DART SIDE DASH PANEL REWORK

Property and Top Bus Number: DART: 304500

Issue: side dash is wavy needs better securement

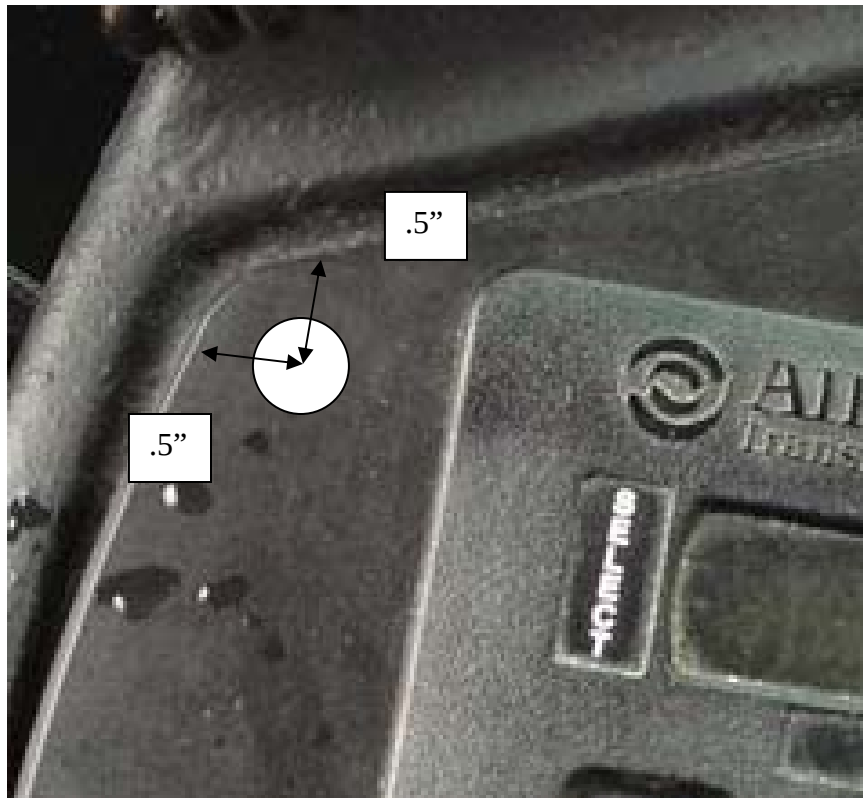
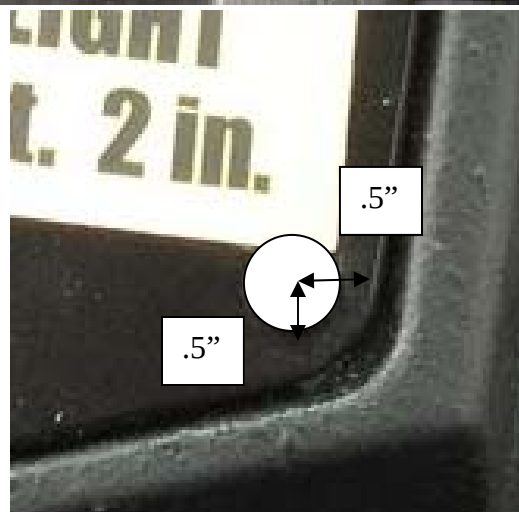
Reason/ cause: PP1 valve is too big to be secured by just two screws

Solution: Add screws to each corner of side dash panel

1. Park the bus and apply the parking brake.
2. Turn off main battery disconnect switch(es).
3. Drill holes in side dash as shown using $\frac{1}{4}$ drill bit

4. After drilling holes remove dash and add retainer clips in center of holes. Add two rivets to each clip to secure. Reinstall dash
5. Check for completeness of work.
6. Remove all tools from working area.
7. Turn the main battery disconnect switch (es) on.
